Report to Sydney Central City Planning Panel

Panel reference	2016SYW191
DA number	JRPP-16-03335
Proposed development	Place of public worship
Street address	33 Hamilton Street, Riverstone
Applicant	Donald Cant Watts Corke (NSW) Pty Ltd
Owner	Anglican Church Property Trust Diocese of Sydney
Date of DA lodgement	2 September 2016
Number of submissions	Nil
Regional development criteria (s9.1 EP & A Act and Ministerial Direction)	Capital investment value (CIV) over \$5 million for a place of public worship (DA has CIV of \$7.66 million)
All relevant s4.15 matters	<ul style="list-style-type: none"> • State Environmental Planning Policy (State and Regional Development) 2011 • State Environmental Planning Policy (Infrastructure) 2007 • Sydney Regional Environmental Plan No. 20 – Hawkesbury-Nepean River • State Environmental Planning Policy No. 55 – Remediation of Land • Central City District Plan 2018 • State Environmental Planning Policy (Sydney Region Growth Centres) 2006 • Blacktown City Council Growth Centre Precincts Development Control Plan 2018

Report prepared by	Blacktown City Council
Report date	16 March 2018
Recommendation	Approval subject to conditions

Figure Extract from the Landscape Plan demonstrating the proposed acoustic barrier fencing along the north-eastern and south-eastern boundaries
(Source: Ecodesign, November 2016)

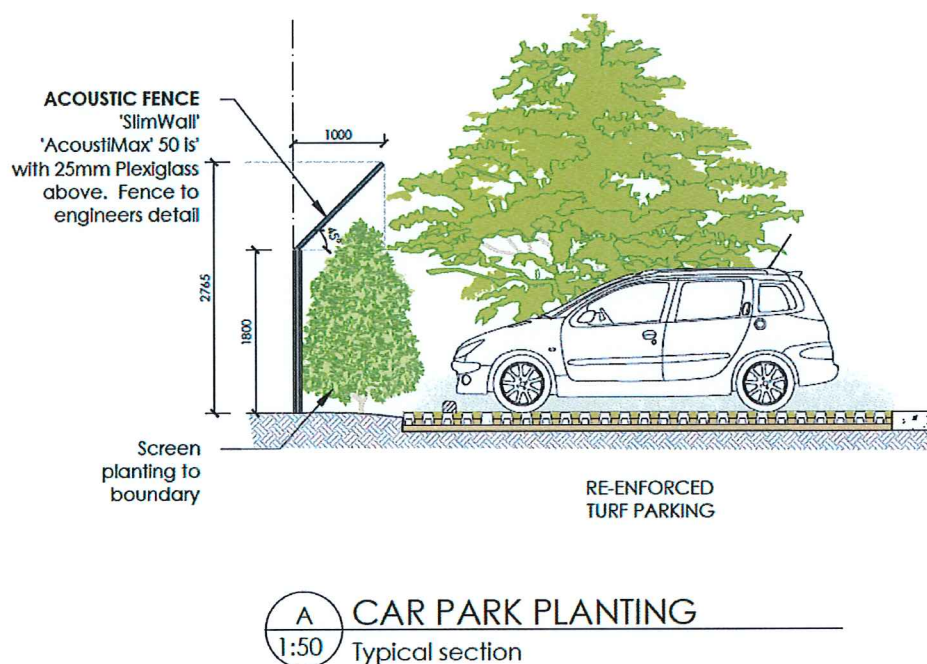
- a. Section 4.2.10 Fencing of the Growth Centre DCP states that the maximum height of side and rear fences should be 1.8 m. The proposal is for fencing to the north-eastern and south-eastern boundaries in the form of a 'SlimWall AcousticMax' acoustic barrier fencing (which is 50 mm thick with an expanded polystyrene core and fibre cement outer walls) with a height of 1.8 m. For noise attenuation purposes, the acoustic barrier fencing then angles in towards the development for 1 m, to provide fencing with a total height of 2.8 m. This upper portion of the fence is to be constructed of product called 'Plexiglass' (being a durable clear, hardened Perspex with acoustic properties) to allow for sunlight access and visual permeability), as demonstrated on the Boundary Treatment Section Plan provided at **attachment 5** and the Figure below:

- b. The proposal originally proposed acoustic barrier fencing having a height of 2.1 m. However, we were concerned that this proposed 2.1 m fence had adverse impacts on the adjoining residential properties due to its height and overshadowing impact. In response to our concerns, this acoustic barrier fencing is now angled inwards within the subject site, and will be transparent.
- c. The proposed boundary fencing is considered to be an appropriate response to potential impacts of the proposal on the visual and acoustic privacy and shadow impacts of the adjoining residential properties, and is supported in this instance.
